## Proposed Modification Of Floating-Point Multiplication

The University of Michigan Computing Center

SUGGESTED REVISION OF THE ROS PROGRAM FOR FLOATING-POINT MULTIPLICATION

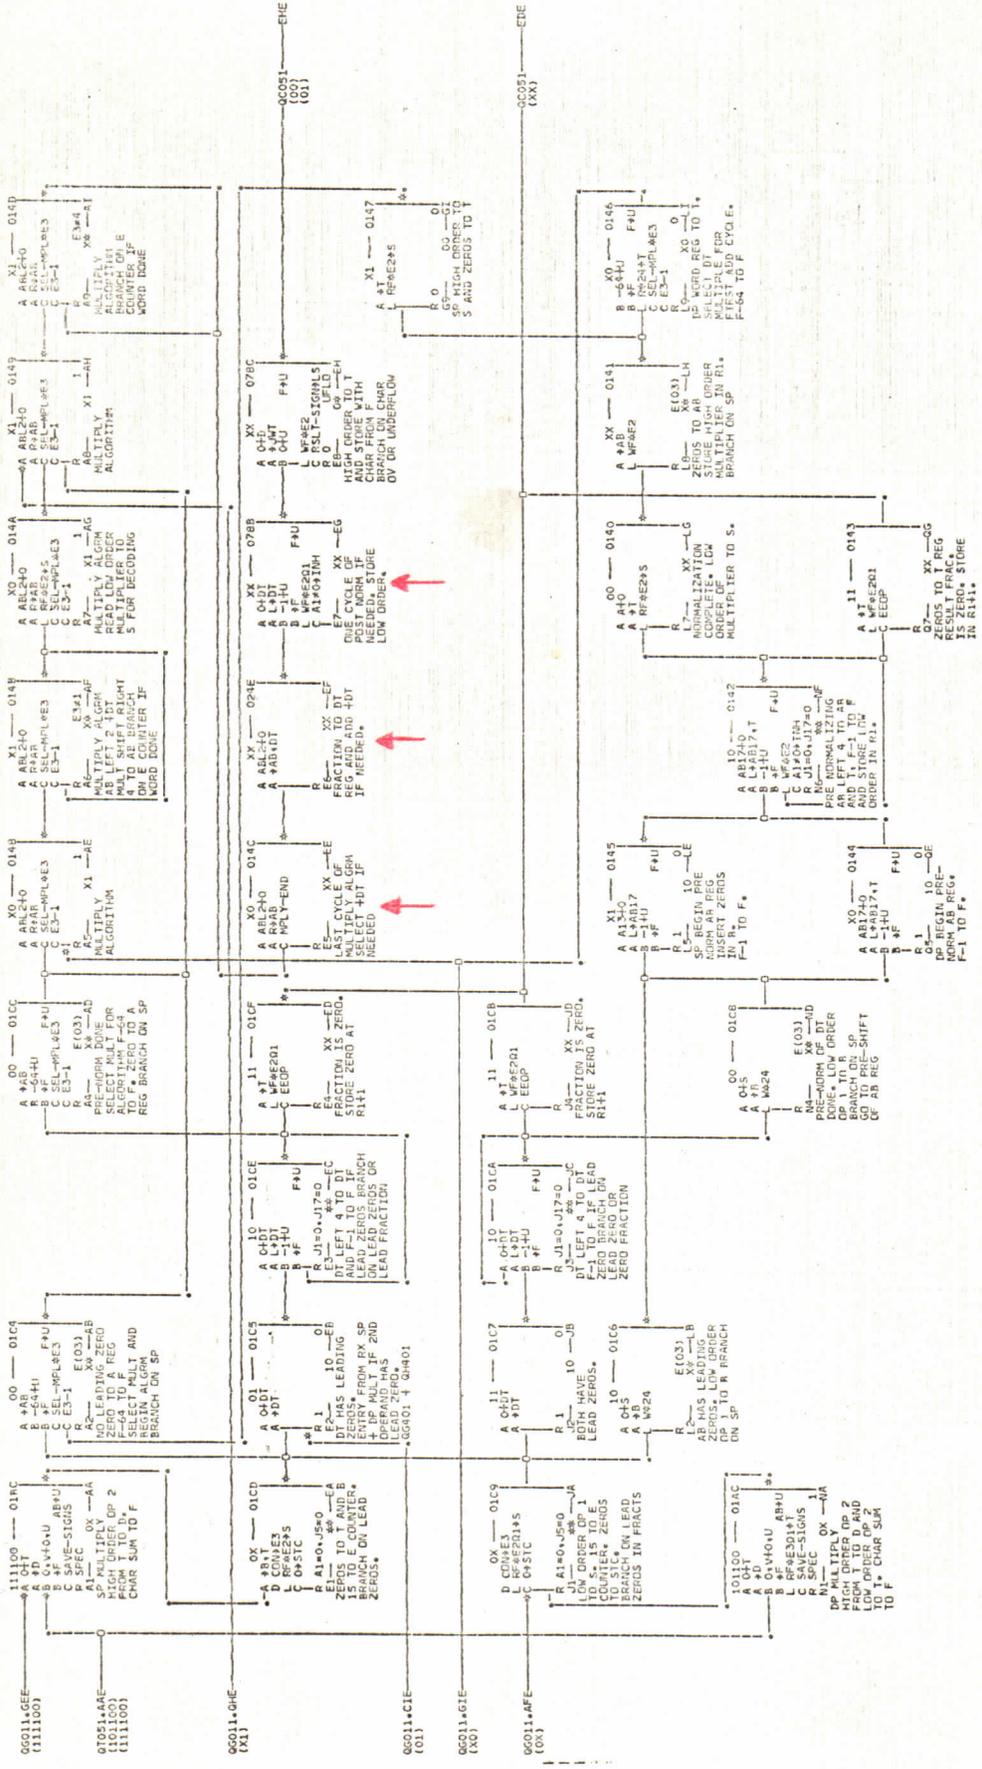
The MD and MDR instructions currently provide for a 14 hexadecimal digit intermediate product; consequently, when postnormalization is necessary the fourteenth digit of the result will always be zero. It would appear that this situation is not necessary, and that minor alterations in the ROS program of the Model 67 will provide for a fifteenth digit in the intermediate product.

Currently, the fifteenth digit of the product is lost two bits at a time. The lower two bits are "shifted" off the end of the PAL, and hence, B register extension. This occurs when the R4 shift is performed after the last multiple selected by the SEL-MPL\*E3 micro-order has been added into the partial product (at 14C). The high order bits of the fifteenth digit are not lost, but remain unused in B(64-65). This is because postnormalization is based on the contents of DT rather than those of AB (at 78B).

A method for retaining the fifteenth digit of the product is thus clear. It suffices to delay the issuance of the MPLY-END micro-order one CPU cycle in order that the partial product resulting from the last SEL-MPL\*E3 micro-order may

be shifted L2 before it is shifted R4. So that the MPLY-END will function properly, this necessitates that the status of the TX-trigger be retained through this additional cycle. If postnormalization is then based on the AB register, the desired result is obtained.

It will be noted that the proposed "patch" decrements the AB-byte counter to 7 and later restores it to zero. This manipulation of the AB-byte counter will prevent the reset of the TX-trigger that would normally occur during clock time of the cycle in which the ROS word in 14C is in control. This AB-byte counter control of the TX-trigger was set up for the extended precision arithmetic package that has been RPQ-ed into our Model 67's.

14C

A	ABL2+0
A	→AB
C	ABC-1
R

\*  
LAST MULTIPLE ADDED TO PARTIAL PRODUCT. MUST SHIFT R2. SET AB-BYTE COUNTER TO 7 TO SAVE TX-TRIGGER

NEW

A	ABL2+0
A	R→AB
C	MPLY-END
R

\*  
ACCOMPLISHES R2 SHIFT WITHOUT LOSING THE LAST TWO PRODUCT BITS. SELECT +DT IF THE TX-TRIGGER IS ON.

24E

A	AB+0
A	→AB,DT
C	ABC+1
R

\*  
15 HEXADECIMAL DIGIT INTERMEDIATE PRODUCT IS IN AB(04-67), 14 DIGIT VERSION IS IN DT. SET AB-BYTE COUNTER BACK TO ZERO.

78B

A	AB+0
A	L→DT
B	-1+U
B	F
L	WF*E2Ω1
C	A1#0→INH
R	F→U

\*  
POSTNORMALIZE FROM AB IF NECESSARY. STORE THE LOW ORDER WORD OF THE RESULT.
